**AGENDA  
PLANNING COMMISSION MEETING  
CITY OF SHOREVIEW**

**DATE: DECEMBER 06, 2011  
TIME: 7:00 PM  
PLACE: SHOREVIEW CITY HALL  
LOCATION: 4600 N. VICTORIA**

**TO:** Planning Commission  
**FROM:** Rob Warwick, Senior Planner  
**DATE:** December 1, 2011  
**SUBJECT:** File No. 2436-11-29; Variance, Caroll Roberts, 200 Dawn Avenue

**SUBJECT:** Variance and Residential Design Review, Alan and Heather Woldt, 800 County Road I, File No. 2435-11-28

PLAT PLAN

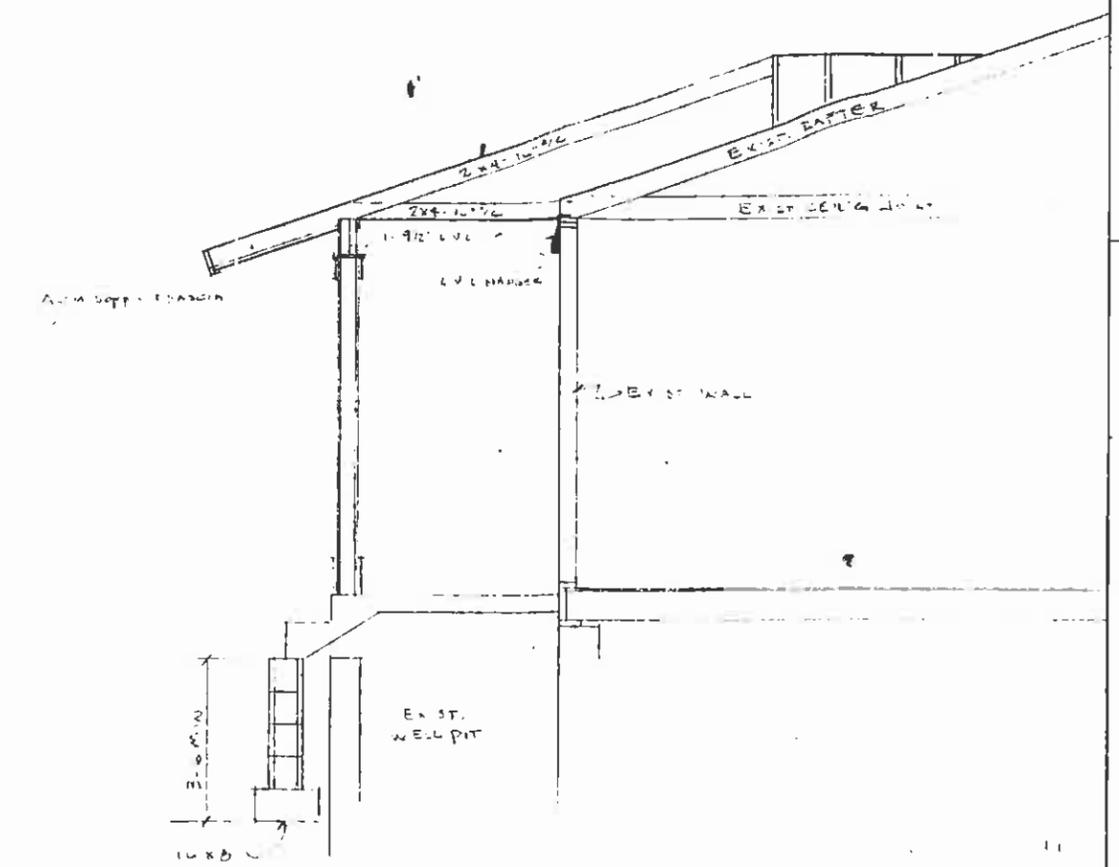
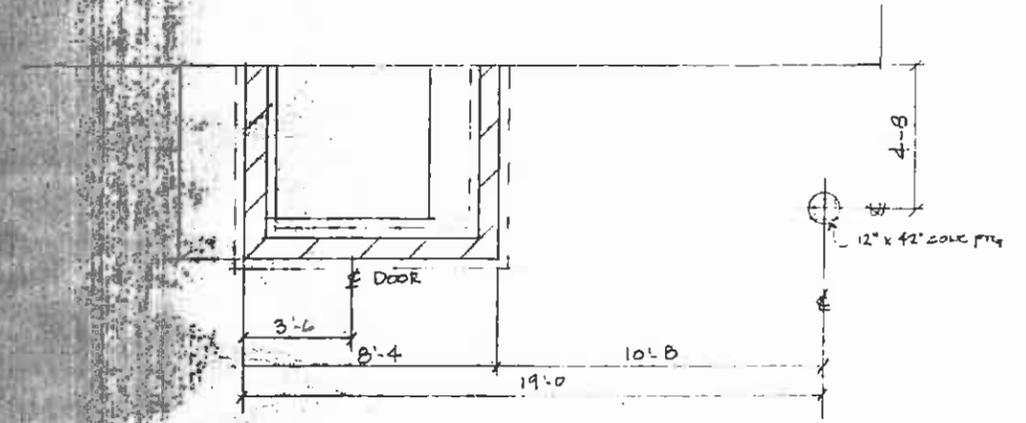
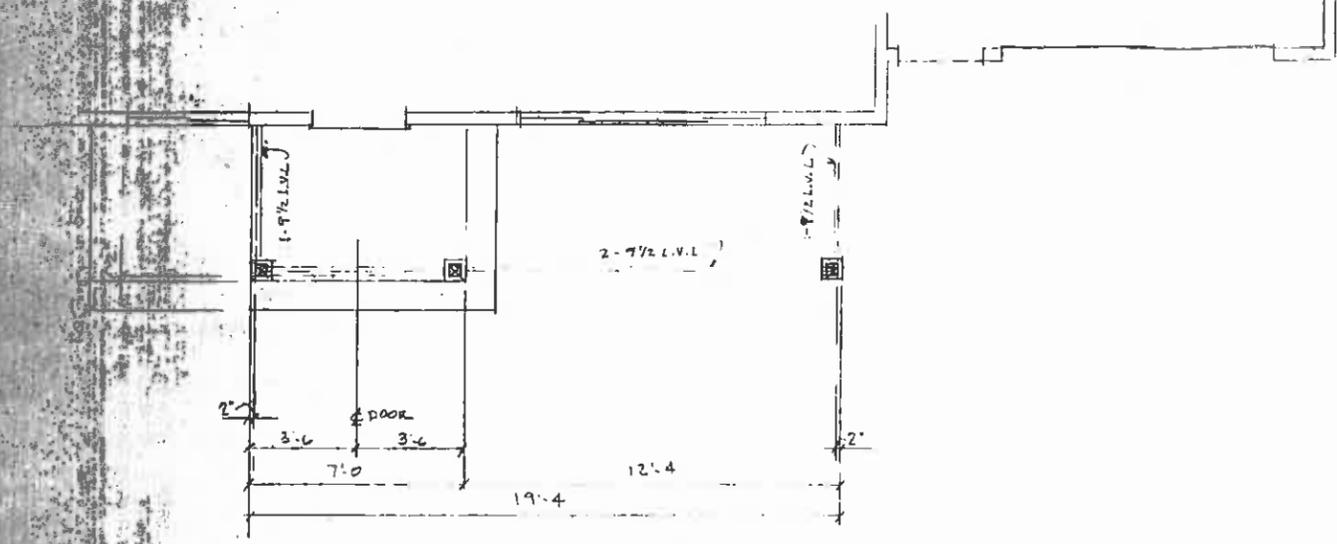
Existing house is setback 32-feet from front property line.

Proposed 6 by 19 foot porch setback 26 feet from the front property line

# CERTIFICATE OF SURVEY ~for~ALAN WOLDT

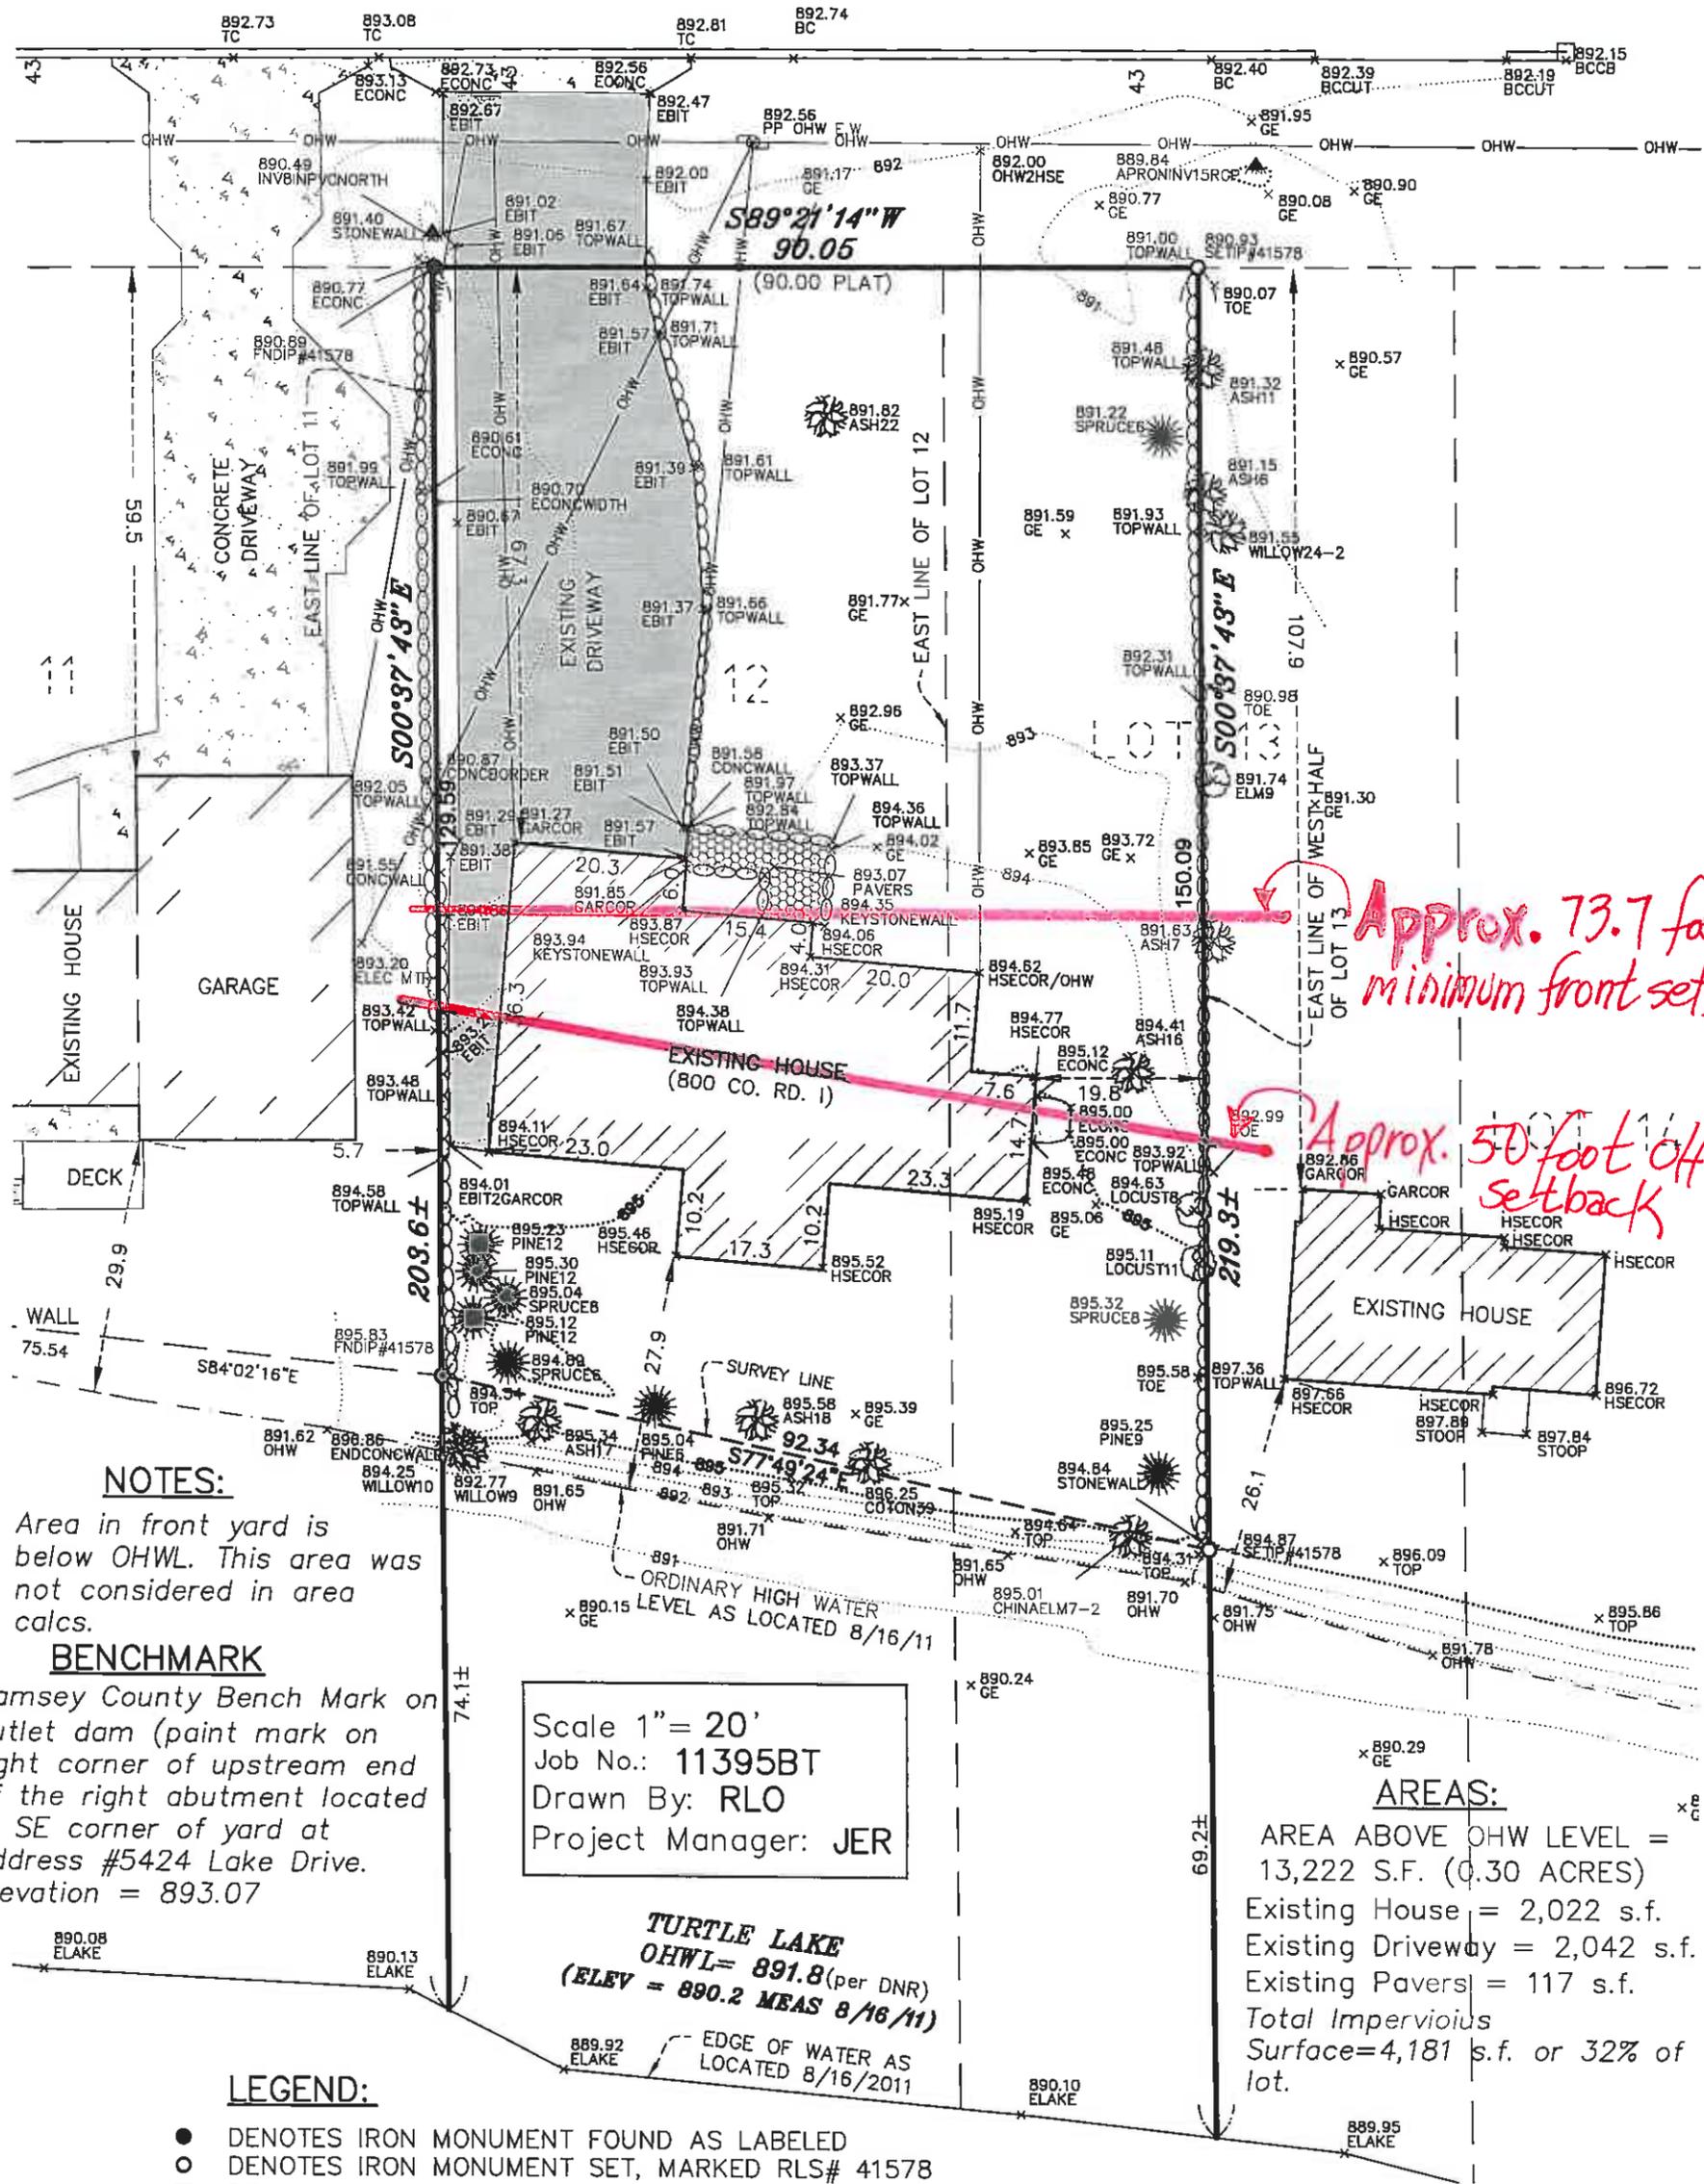
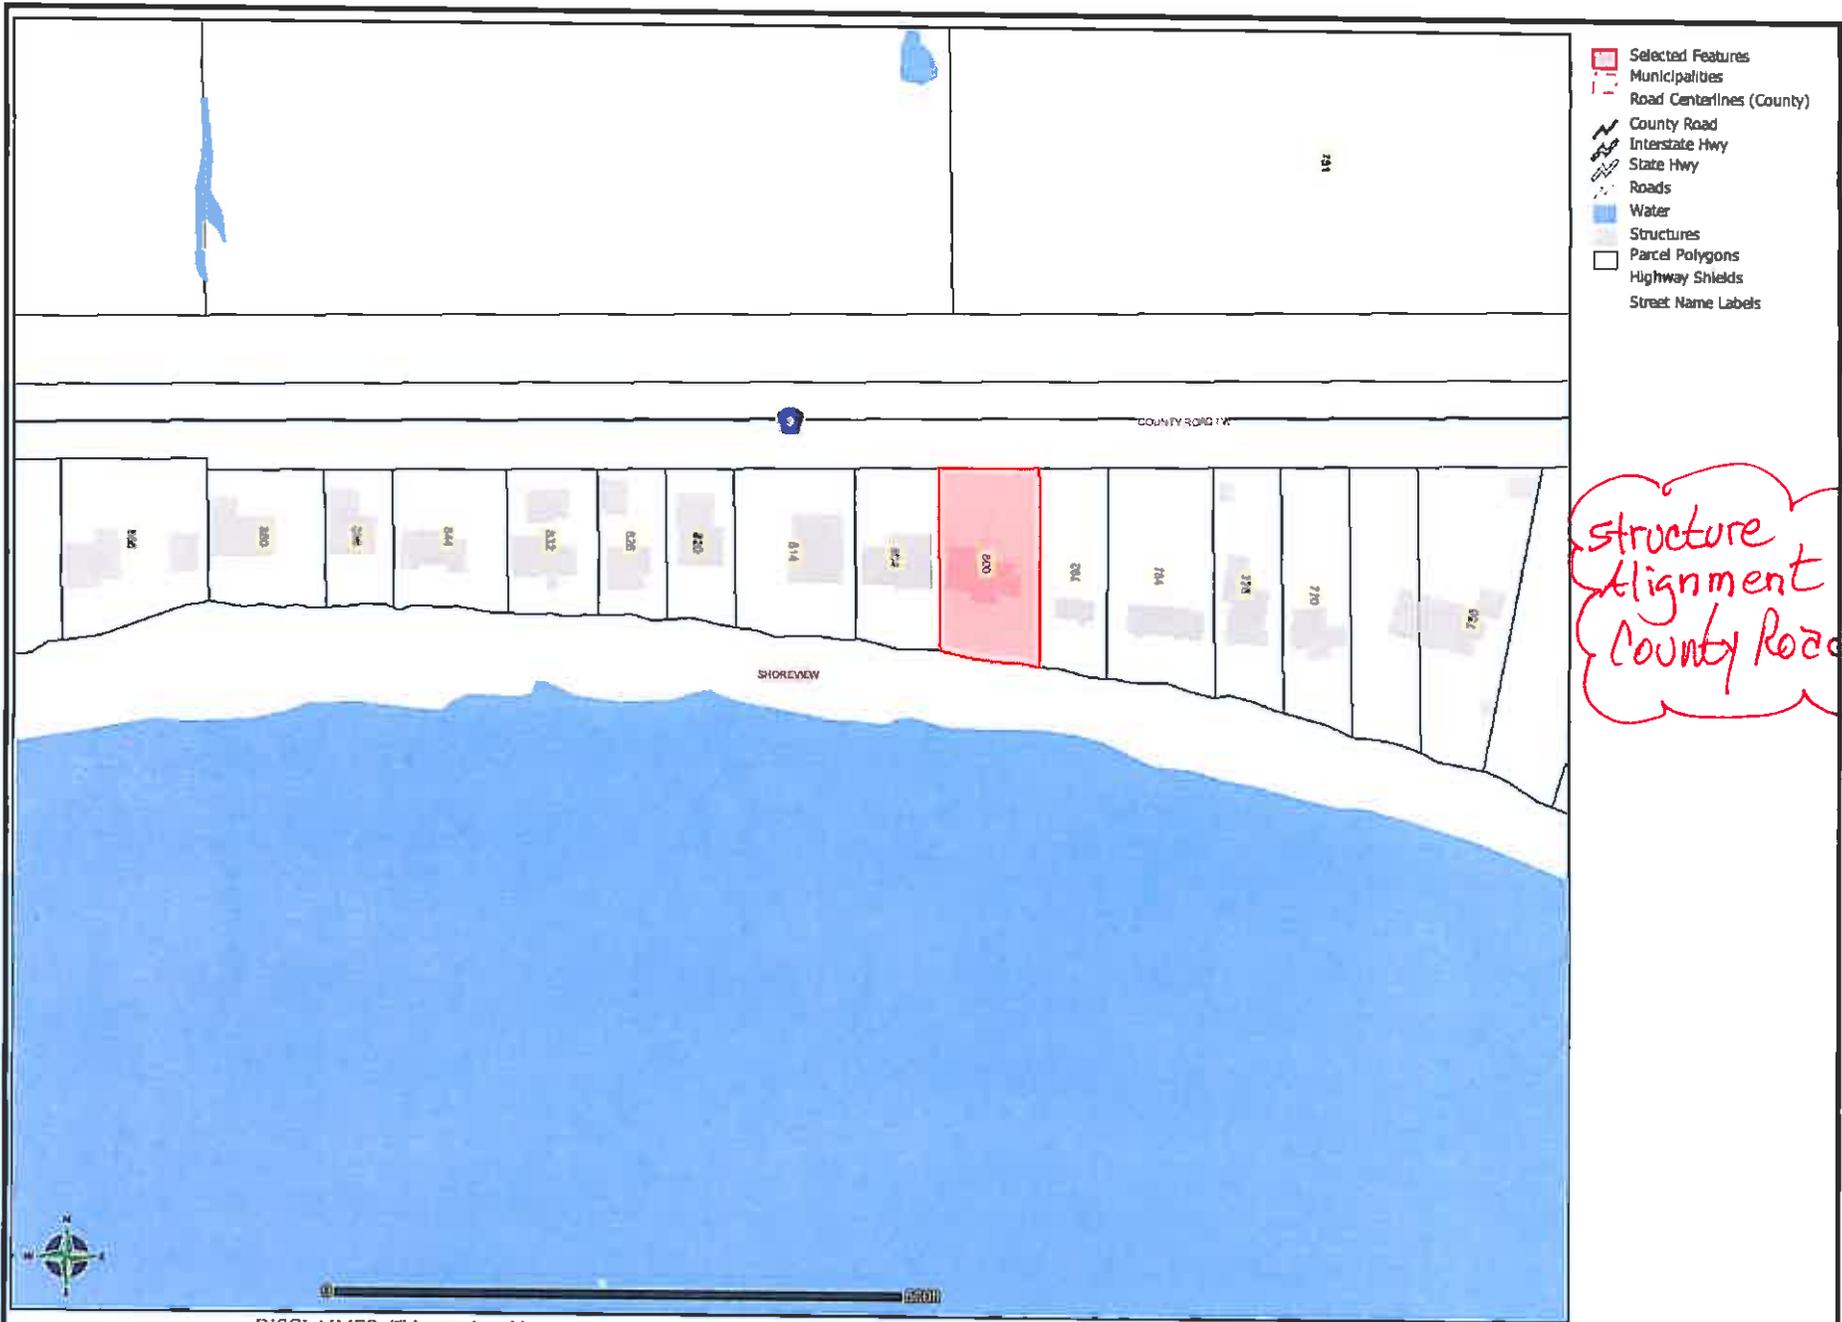
Staff agrees that practical difficulties are present for the setback variance request. The proposed house and attached garage have a foundation area of 2380 square feet, as allowed by Code, and so staff finds this to represent a reasonable use of the property. Based on the minimum 73.7 foot front and 50 foot OHW setbacks, the resulting building pad has a depth of about 12 feet on the west side and 25 feet on the east side of the lot and has an area less than 1,300 square feet. This pad is very narrow and is not sufficient for the 2380 square foot foundation area (18% of lot area) permitted by Code on this 13,200 square foot lot. See the attached survey showing the existing conditions and minimum setback lines.

The front setback calculation is based on the principal structures on the adjacent lots. The small house to the east is not only located near the OHW, but that property is also deeper than the subject property due to the curving shore of the lake. This combination of circumstances results in a large front setback that increases the minimum front setback for the subject property.

While less than the calculated front setback, the proposed 45.1 foot front setback does exceed the 40-foot minimum setback specified by Code from an arterial street. In staff's opinion, a 2380 square foot building pad located in compliance with the OHW setback requirement and the minimum 40 foot arterial setback is a reasonable proposal to address the unique circumstances presented for this property.

The Assistant City Engineer has reviewed the grading and drainage plan and found it acceptable, provided that gutters and downspouts direct discharge to the front and lakeside yards, not to side yards.
